25 January 2005

RE: Addendum 2 to Geotechnical Investigation and Report  
Proposed City Library  
Mt. Diablo Boulevard at First Street  
Lafayette, California

**FIGURE 1**  
**BEDROCK CONTOURS**

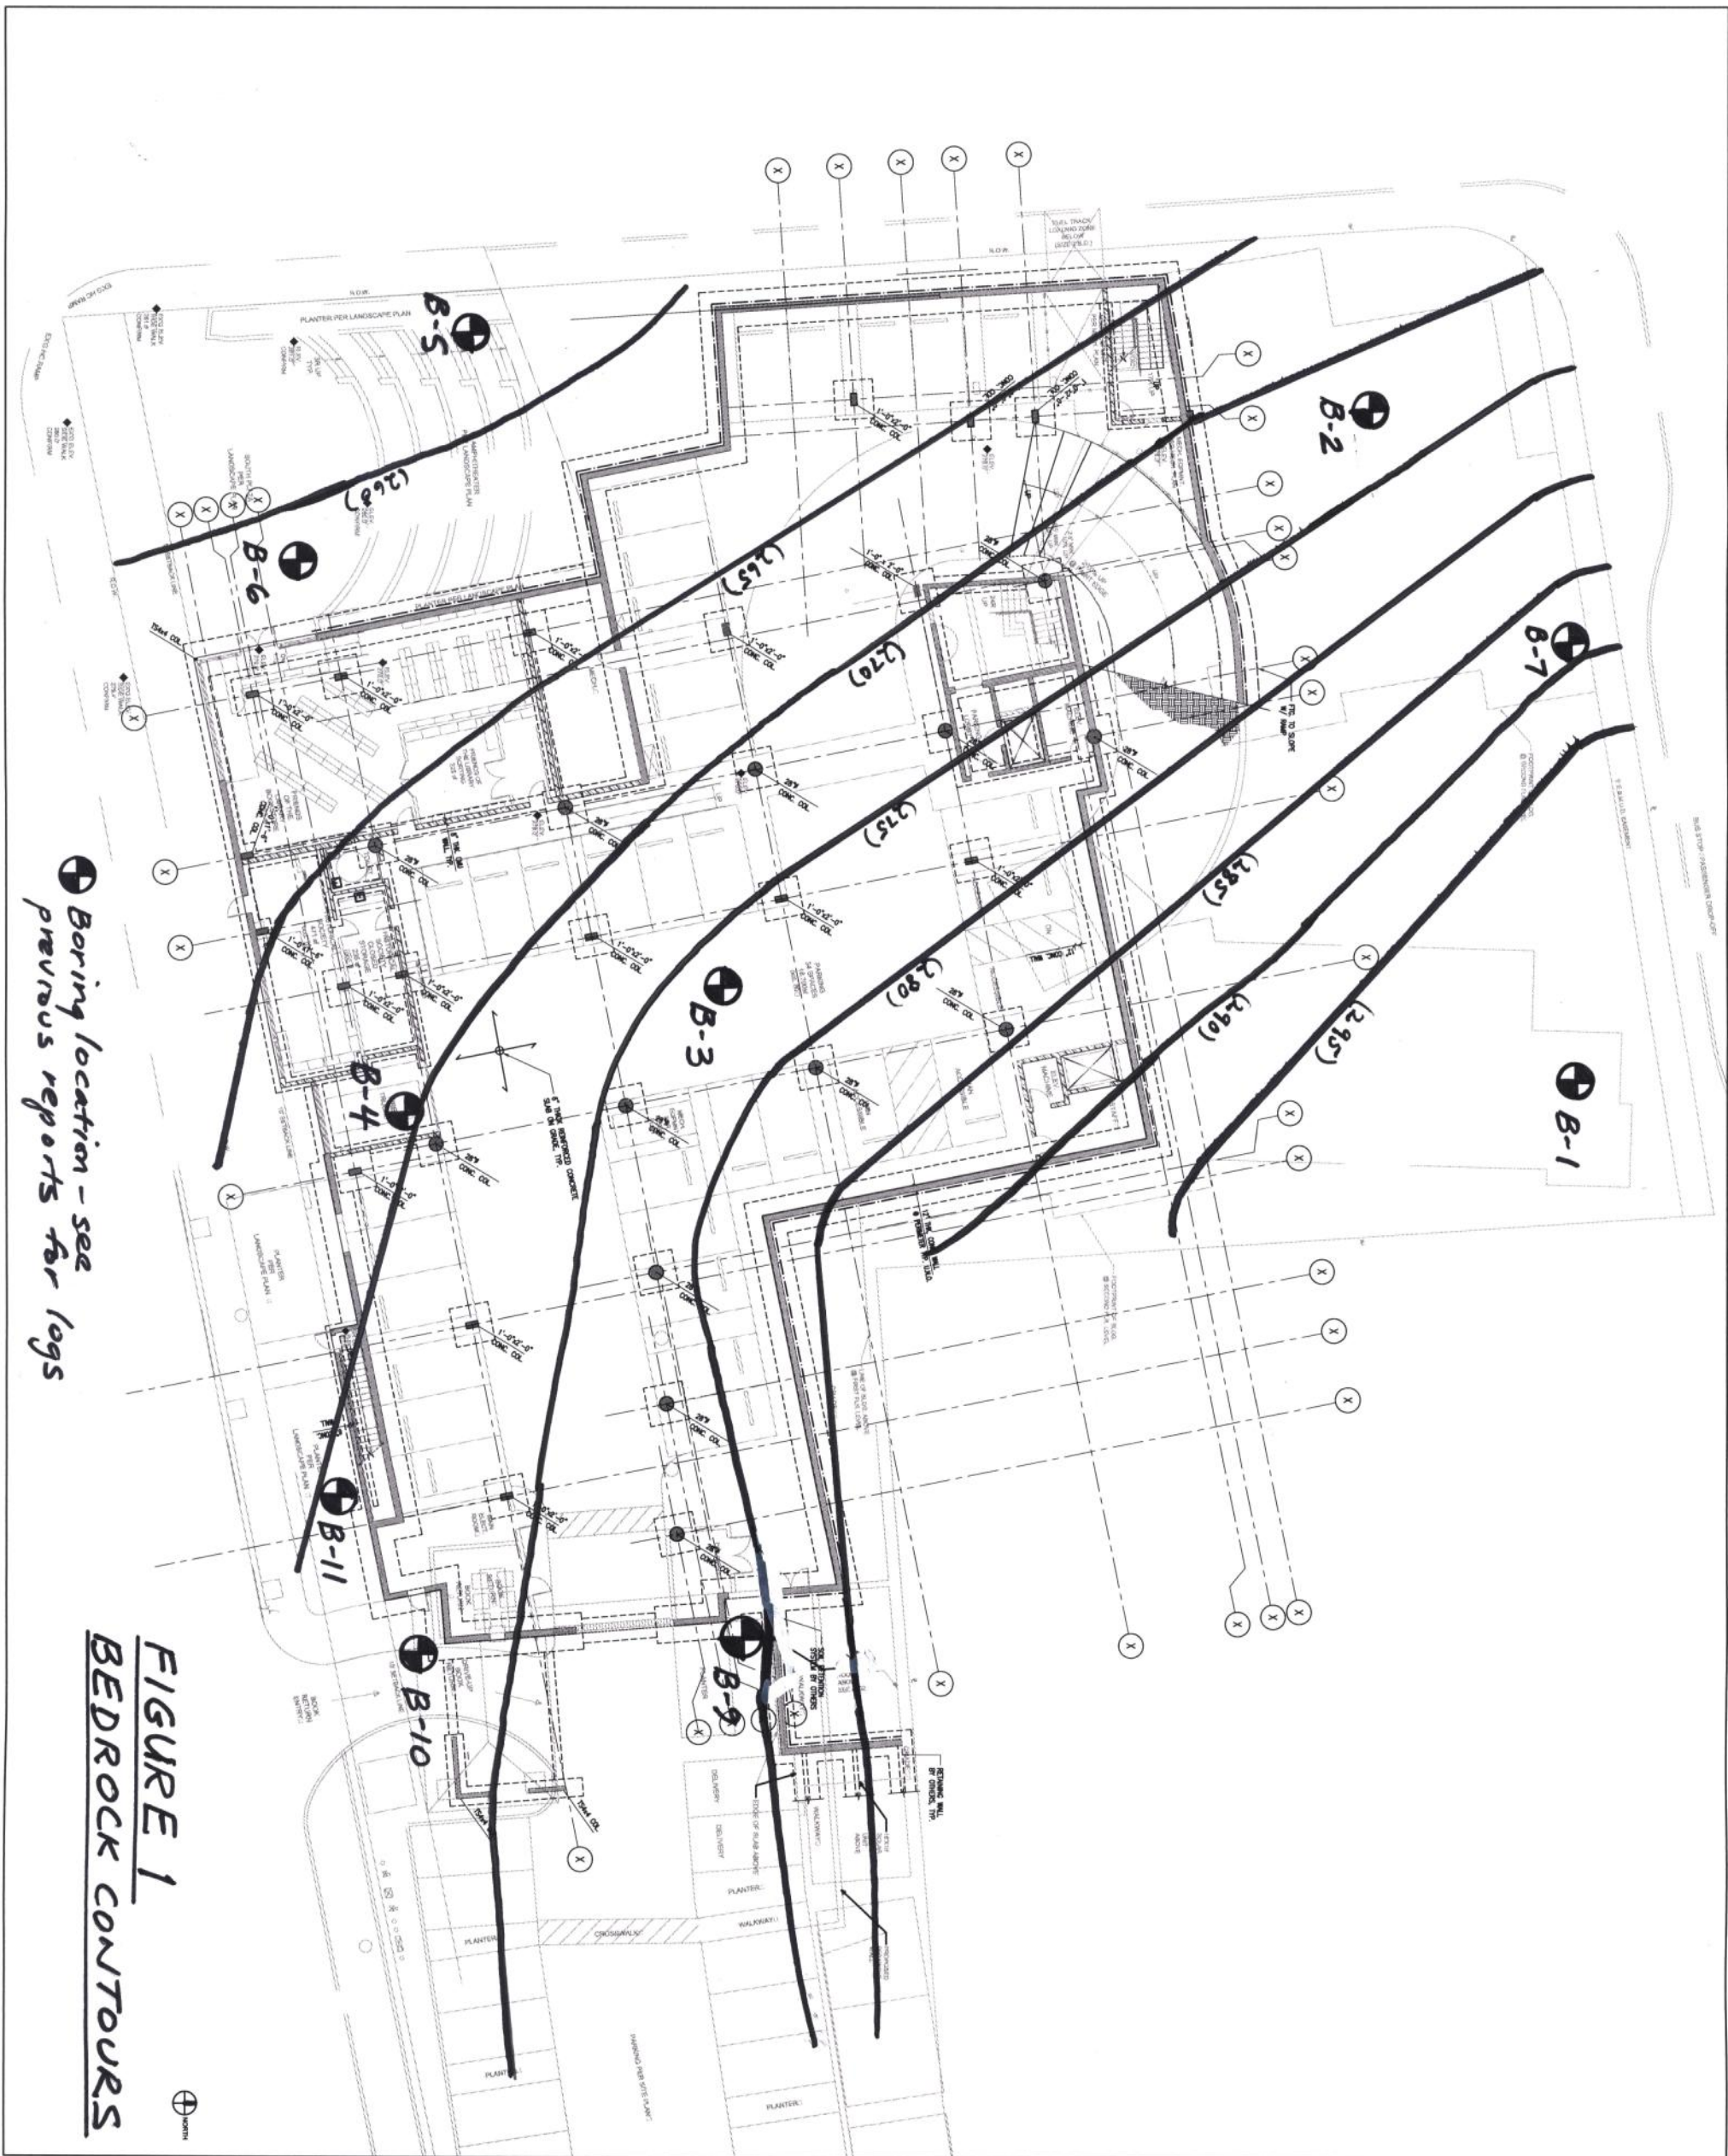
To better understand the subsurface conditions in the context of the proposed construction, we reviewed the boring logs for the site and developed a bedrock contour map. The bedrock contours were then overlaid on a current plan for the site (see Figure 1). The bedrock contours shown on Figure 1 represent our interpretation of the surface of the bedrock that we consider to be suitable for foundation support. The bedrock contours neglect the 2 to 5 foot thick layer of weathered bedrock section which is considered unsuitable for foundation support.

We recommend that conventional spread footings supported on competent bedrock be utilized in the area where bedrock is encountered at or above the basement floor elevation of 275. Figure 1 can be used to determine what portions of the building footprint will likely encounter bedrock at 275 or higher. Design parameters for conventional spread footings can be found in our 21 May 2003 report.

In the area where the bedrock is encountered between elevation 270 and 275, it is our opinion that conventional footings that bear on competent bedrock can also be used but will require localized excavation of 5 to 8 feet deep. We recommend that continuous footings should not exceed a total depth of 5 feet, including the required bedrock embedment. Pad footings should not exceed a total depth of 8 feet, including the required bedrock embedment. Temporary shoring may be locally required for deepened continuous footings.

For the area where the bedrock is anticipated to be encountered below elevation 270, we recommend that a deep foundation be utilized. The depth to bedrock in this area will vary from about 5 to 15 feet below the basement subgrade. It is anticipated that alluvium and ground water will be encountered along the west side of the structure that adjoins First Street and along the extreme western portion of the south side of the structure.
